# Highway Changes Prompted by 2026 Mileage Certificates

# Vermont Agency of Transportation

Wednesday, May 27, 2026

**Mileage Certificate Changes 2026  
FAIRFIELD TH-73**

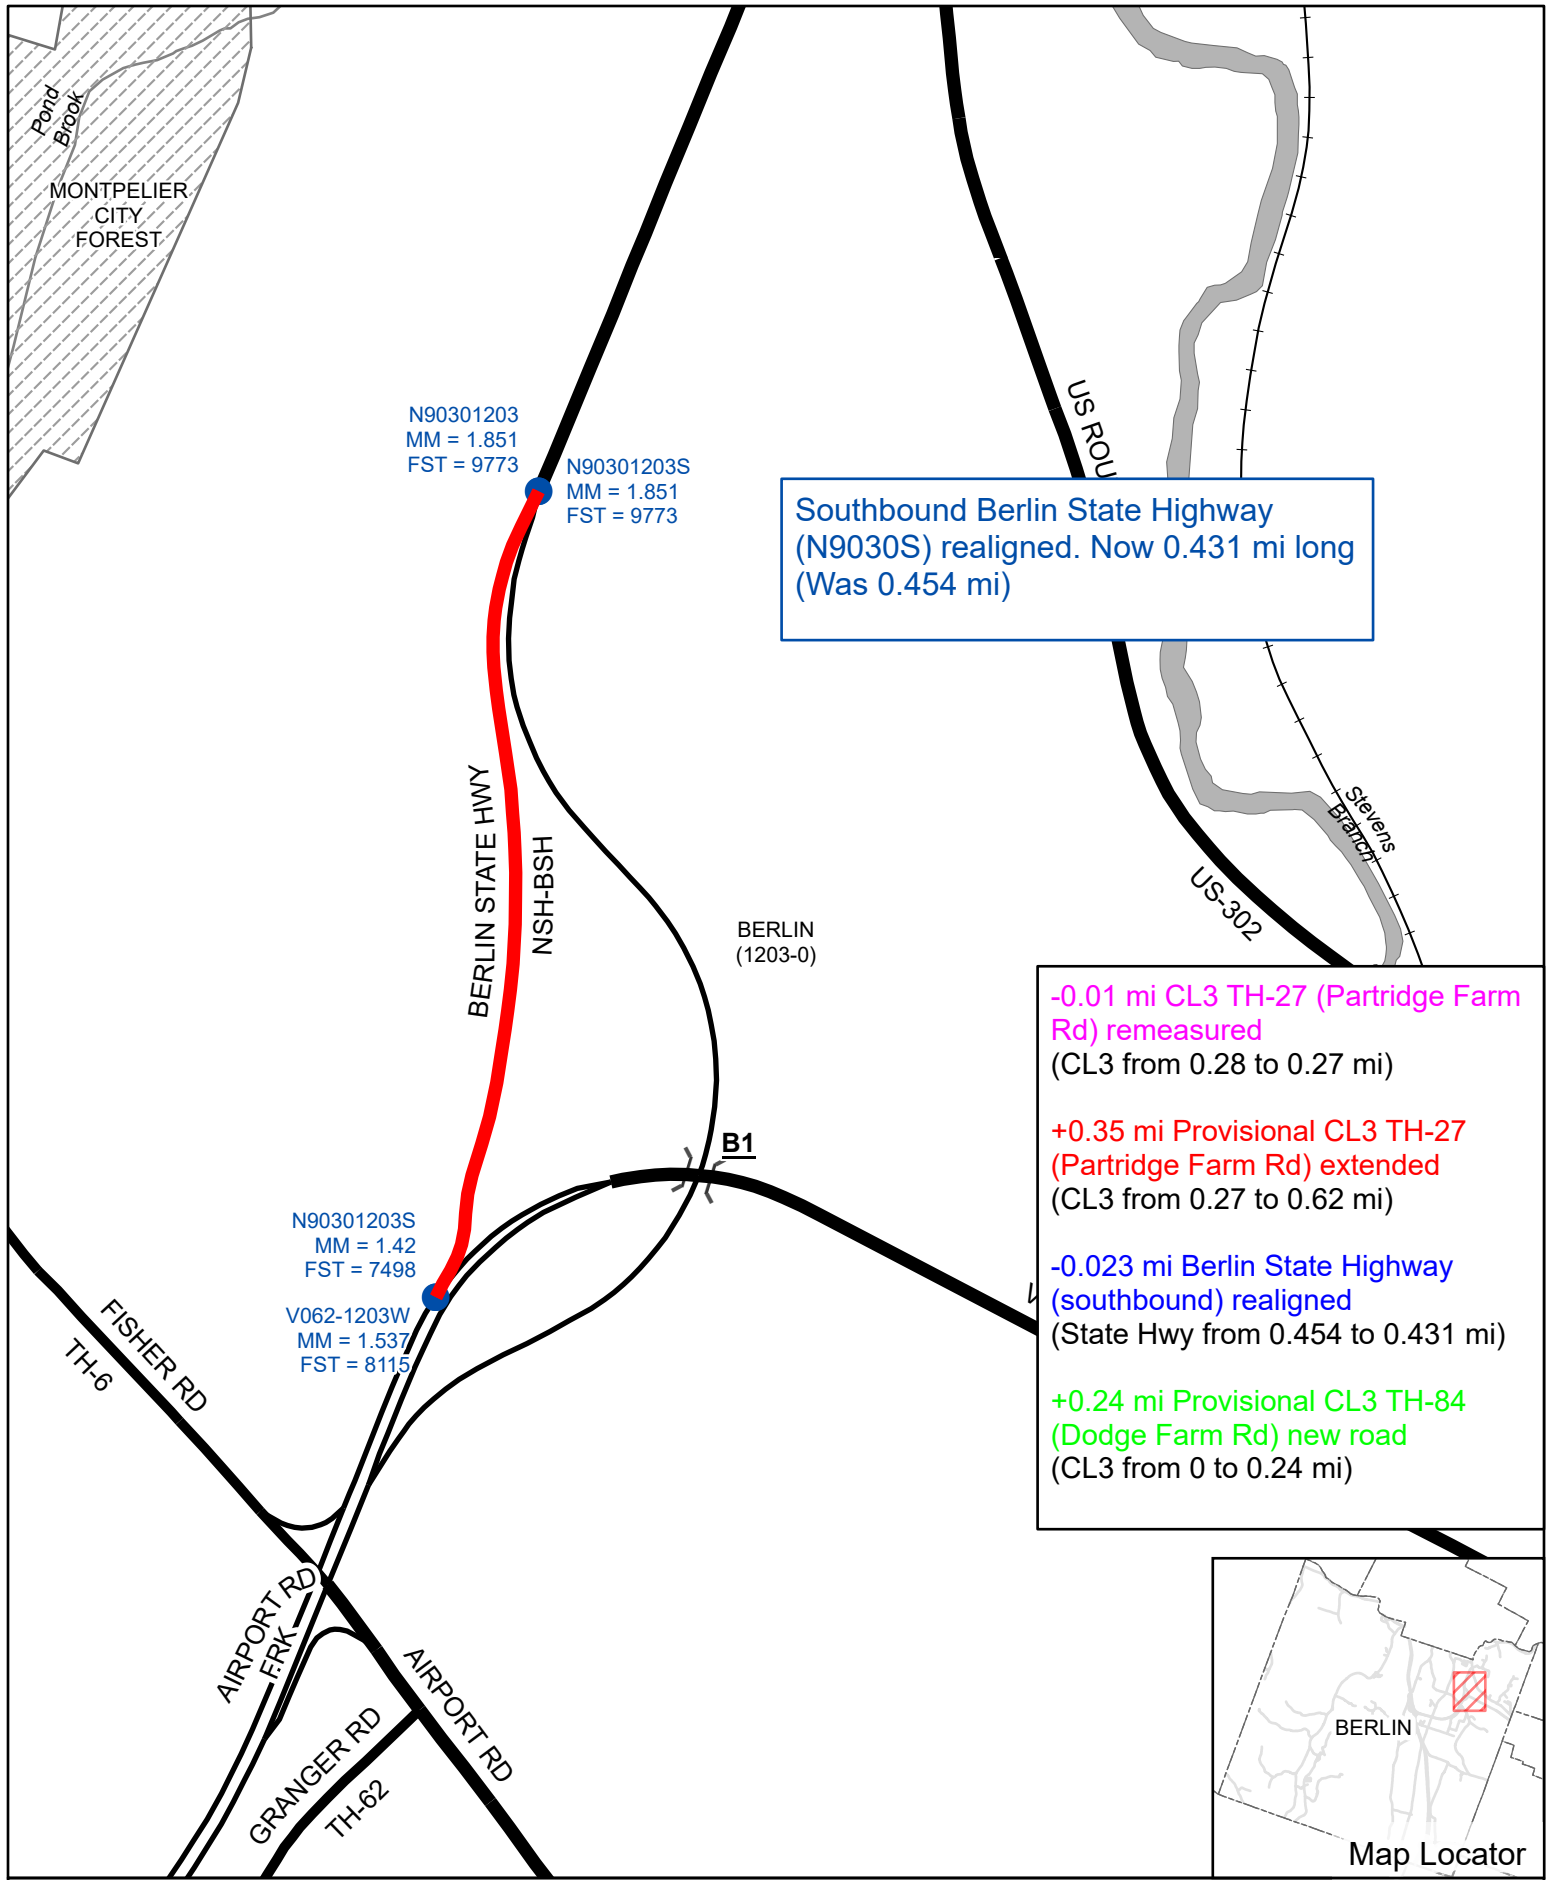
Off VT-36, CL4 TH-73 (Sherman St)  
discontinued at MM = 9.836, south  
(right) side - was NUTs

-0.17 mi CL4 TH-73 (Sherman St)  
discontinued - was NUTs

(CL4 TH-73 from 0.17 to 0 mi)
